Access Compliance Report

Public Rights-of-Way

(Curb Ramps)

Intersection ID: 46913	Main Street: PONDEROSA_PINE_LN	Cross Street: PINYON_PINE_LN	Location: S
ADA ID: 70336E143A49	Ramp Type: PerpDiag	Initial Pass/Fail: Fail	Overall Compliance: No
		Severity Score: 25

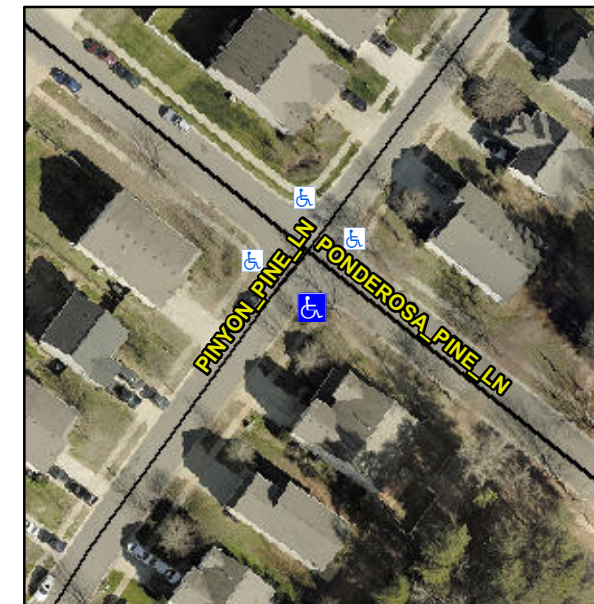
Not Found, R304.5.3

Compliance	Description	Data	Compliance	Description	Data
N/A	Ramp Length (in)	83.5	Yes	Ramp Slope (%)	7.3
Yes	Ramp Width (in)	48.0	No	Ramp XSlope (%)	9.3
N/A	Flare Type LT	N/A	N/A	Flare Type RT	N/A
N/A	Flare Slope LT (%)	N/A	N/A	Flare Slope RT (%)	N/A
N/A	Flare Traversable LT?	N/A	N/A	Flare Traversable RT?	N/A
N/A	Landing Length (in)	N/A	N/A	DWS Provided?	N/A
N/A	Landing Width (in)	N/A	N/A	DWS Contrast?	N/A
N/A	Landing Slope (%)	N/A	N/A	DWS Length (in)	N/A
N/A	Landing X Slope (%)	N/A	N/A	DWS Full Width?	N/A
N/A	Landing Curb? (Y/N)	N/A	N/A	DWS Offset (in)	N/A
N/A	Shared Landing?	N/A			
N/A	Gutter Ponding?	N/A	N/A	Gutter Slope (%)	N/A
N/A	Gutter Lip Ht (in)	0.5	N/A	Gutter X Slope (%)	N/A
N/A	Painted X Walk1?	No	N/A	Painted X Walk2?	No
	X Walk 1 Direction	To NE		X Walk 2 Direction	To NW
N/A	X Walk 1 Width (in)	N/A	N/A	X Walk 2 Width (in)	N/A
	X Walk 1 Slope (%)	4.2		X Walk 2 Slope (%)	1.1
	X Walk 1 X Slope (%)	4.8		X Walk 2 X Slope (%)	3.4

Remove & Replace Curb Ramp With Two New Directional Ramps or Equivalent.
